cROP Significance Determination Process 6-16-10

DRAFT

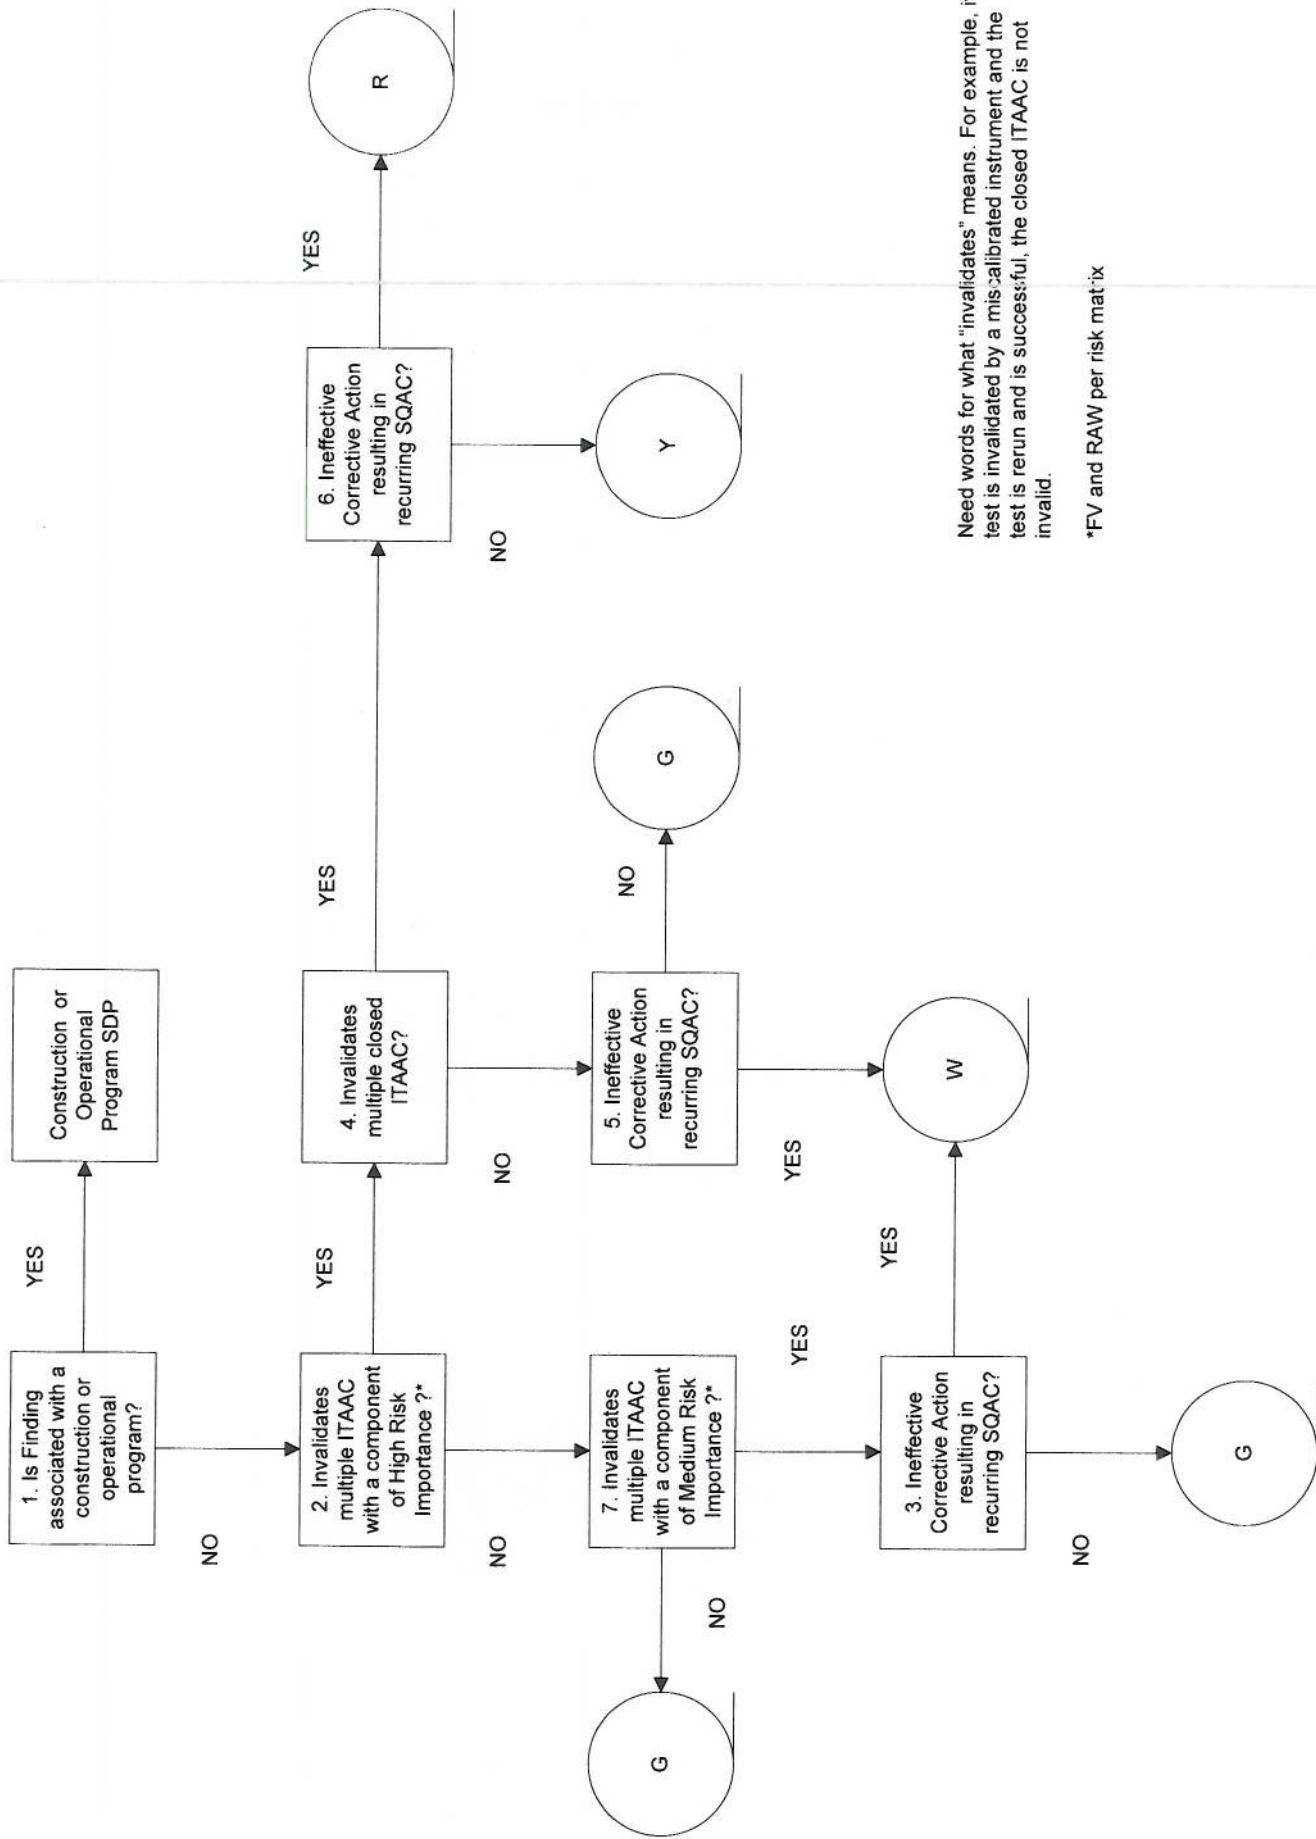
Need words for what "invalidates" means. For example, if a test is invalidated by a mis-calibrated instrument and the test is rerun and is successful, the closed ITAAC is not invalid.

*FV and RAW per risk matrix
